INDIA'S COMMENTS ON ECE REGULATION NO. 37

India suggests modification in the current text of the Regulation 37 as follows: (additions are marked in **bold** characters).

A. PROPOSAL

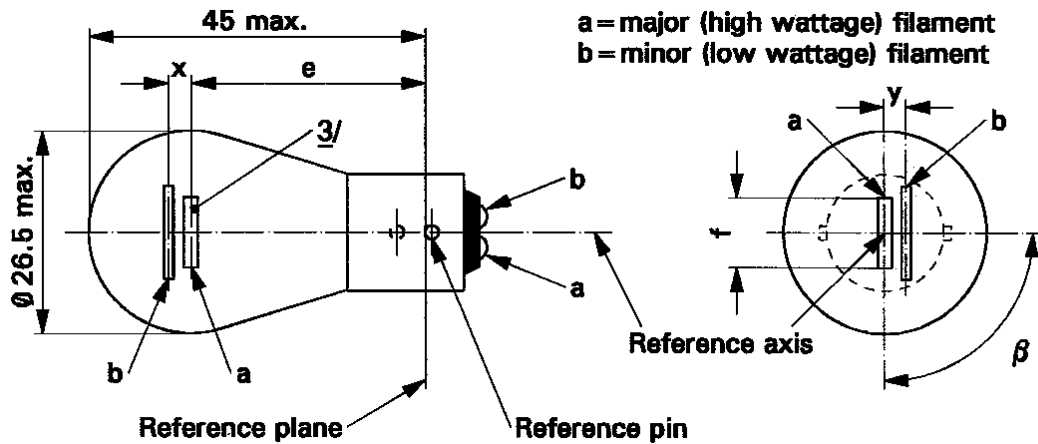
Insert new sheets P18/5 /1 to 3, between sheet P13W/1 to 3 and sheet PR18/5 /1 to 3, to

Dimensions in mm		Filament lamps of normal production			Standard filament lamp
		min.	nom.	max.	
e	6, 12 V		31.8 <u>1/</u>		31.8 ± 0.3
	24 V	30.8	31.8	32.8	
f	6, 12 V			7.0	7.0 + 0/- 2
Lateral deviation <u>2/</u>	6, 12 V			<u>1/</u>	0.3 max.
	24 V			1.5	
x, y	6, 12 V		<u>1/</u>		2.8 ± 0.3
x	24 V <u>3/</u>	-1.0	0	1.0	
y	24 V <u>3/</u>	1.8	2.8	3.8	
β		75°	90°	105°	90° ± 5°

Cap BAY15d in accordance with IEC Publication 60061 (sheet 7004-11B-7)

Screen projection requirements

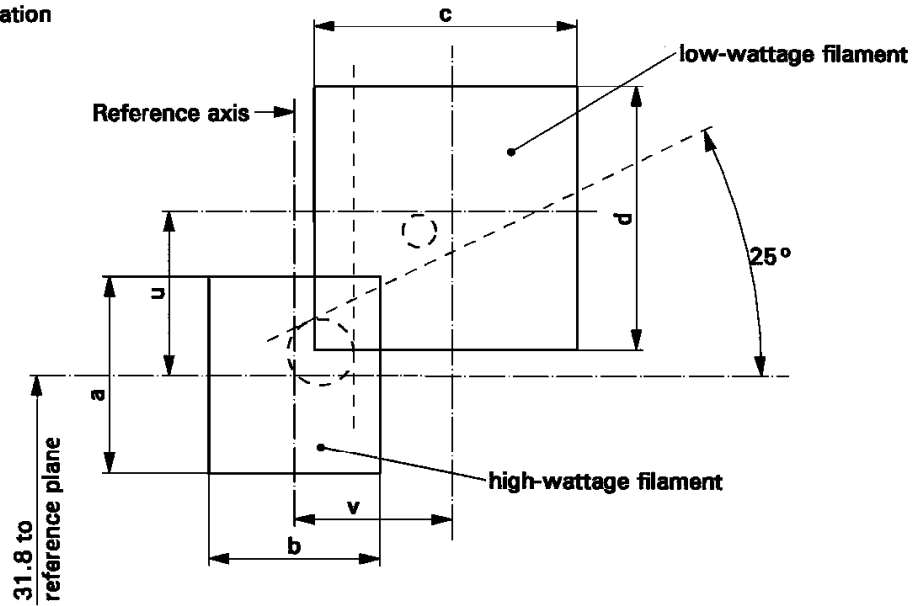
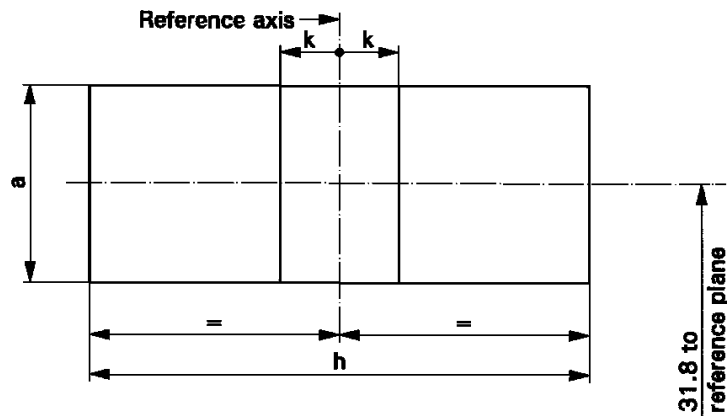
This test is used to determine, by checking whether:

- (a) the major (high wattage) filament is correctly positioned relative to the reference axis and reference plane and has an axis perpendicular, within $\pm 15^\circ$, to the plane through the centres of the pins and the reference axis; and whether
- (b) the minor (low wattage) filament is correctly positioned relative to the major (high wattage) filament, whether a filament lamp complies with the requirements.

- 1.** The filament lamp is placed in a holder capable of being rotated about its axis and having either a calibrated scale or fixed stops corresponding to the angular displacement tolerance limits. (i.e. 15°). The holder is then so rotated that an end view of the major filament is seen on the screen on which the image of the filament is projected. The end view of that filament shall be obtained within the angular displacement tolerance limits.

- 2.** Side elevation
The filament lamp placed with the cap down, the reference axis vertical, the reference pin to the right and the major filament seen end-on:

- 2.1.** the projection of the major filament shall lie entirely within a rectangle of height "a" and width "b", having its centre at the theoretical position of the centre of the filament;

- 2.2.** the projection of the minor filament shall lie entirely:
 - 2.2.1.** within a rectangle of width "c" and height "d" having its centre at a distance "v" to the right of and at a distance "u" above the theoretical position of the centre of the major filament;

- 2.2.2.** above a straight line tangential to the upper edge of the projection of the major filament and rising from left to right at an angle of 25° .

- 2.2.3.** to the right of the projection of the major filament.
- 3.** Front elevation
The filament lamp being placed with the cap down and the reference axis vertical, the filament lamp being viewed in a direction at right angles to axis of the major filament:

- 3.1. the projection of the major filament shall lie entirely within a rectangle of height "a" and width "h", centred on the theoretical position of the centre of the filament;**
- 3.2. the centre of the major filament shall not be offset by more than distance "k" from the reference axis.**
- 3.3. the centre of the minor filament axis shall not be offset from the reference axis by more than ± 2 mm (± 0.4 mm for standard filament lamps).**

Reference	a	b	c	d	u	v
Dimensions	3.5	3.0	4.8		2.8

Reference	a	h	k
Dimensions	3.5	9.0	1.0

Sheet PR18/5W/1

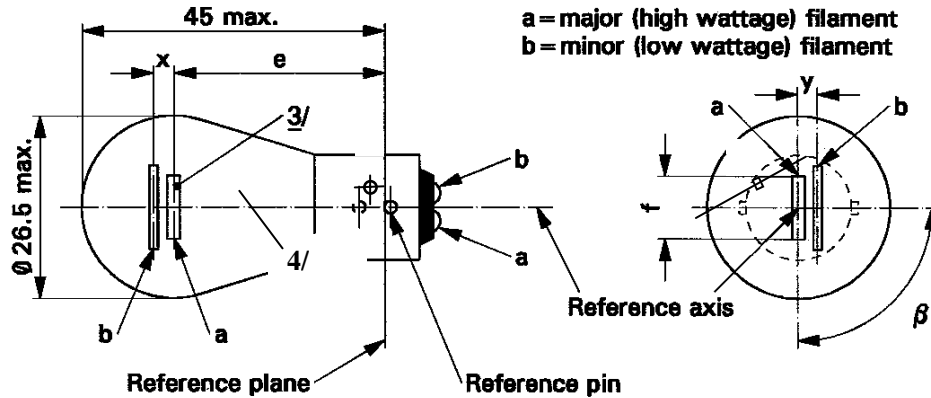
Insert new sheets PR18/5 /1 to 3, between sheet P18/5W/1 to 3 and sheet P19W/1 to 3, to read:
"

Dimensions in mm		Filament lamps of normal production ^{4/}			Standard filament lamp
		min.	nom.	max.	^{5/}
e	12 V		31.8 ^{1/}		31.8 ± 0.3
	24 V	30.8	31.8	32.8	
f	12 V			7.0	7.0 + 0/- 2
Lateral deviation ^{2/}	12 V			^{1/}	0.3 max.
	24 V			1.5	
x, y	12 V		^{1/}		2.8 ± 0.3
x	24 V ^{3/}	-1.0	0	1.0	
y	24 V ^{3/}	1.8	2.8	3.8	
β		75°	90°	105°	90° ± 5°

Cap BAW15d in accordance with IEC Publication 60061 (sheet 7004-11E-1)

Rated values	Volts	12		24		12
	Watts	18	5	18	5	18/5
Test voltage	Volts	13.5		28.0		13.5
Objective values	Watts	23.5 max.	6.6 max.	26.7 max.	11 max.	23.5 and 6.6 max.
	Luminous flux ± %	76	8	76	10	
Reference luminous flux at approximately 13.5 V:		White: 325 lm and 35 lm		Red: 76 lm and 8 lm

Sheet W10W/1

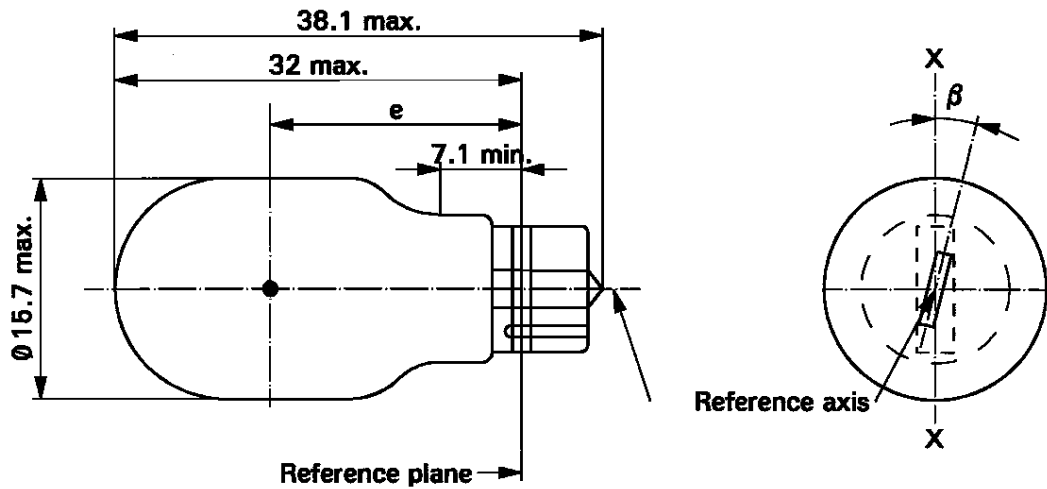
Insert new sheets W10W /1 to 3, between sheet W5W/1 and sheet W16W/1, to read:

Dimensions in mm	Filament lamps of normal production			Standard filament lamp
	min.	nom.	max.	
e	18.3	20.6	22.9	20.6 ± 0.3
Lateral deviation <u>1/</u>			1.0	0.5 max.
β	-15°	0°	+ 15°	0° ± 5°
Cap W2.1x9.5d in accordance with IEC Publication 60061 (sheet 7004-91-3)				
ELECTRICAL AND PHOTOMETRIC CHARACTERISTICS				
Rated values	Volts	12		12
	Watts	10		10
Test voltage	Volts	13.5		13.5
Objective values	Watts	11 max.		11 max.
	Luminous flux	125 ± 20 %		
Reference luminous flux: 125 lm at approximately 13.5 V

1/ Maximum lateral deviation of filament centre from two mutually perpendicular planes both containing the reference axis and one containing axis X-X.
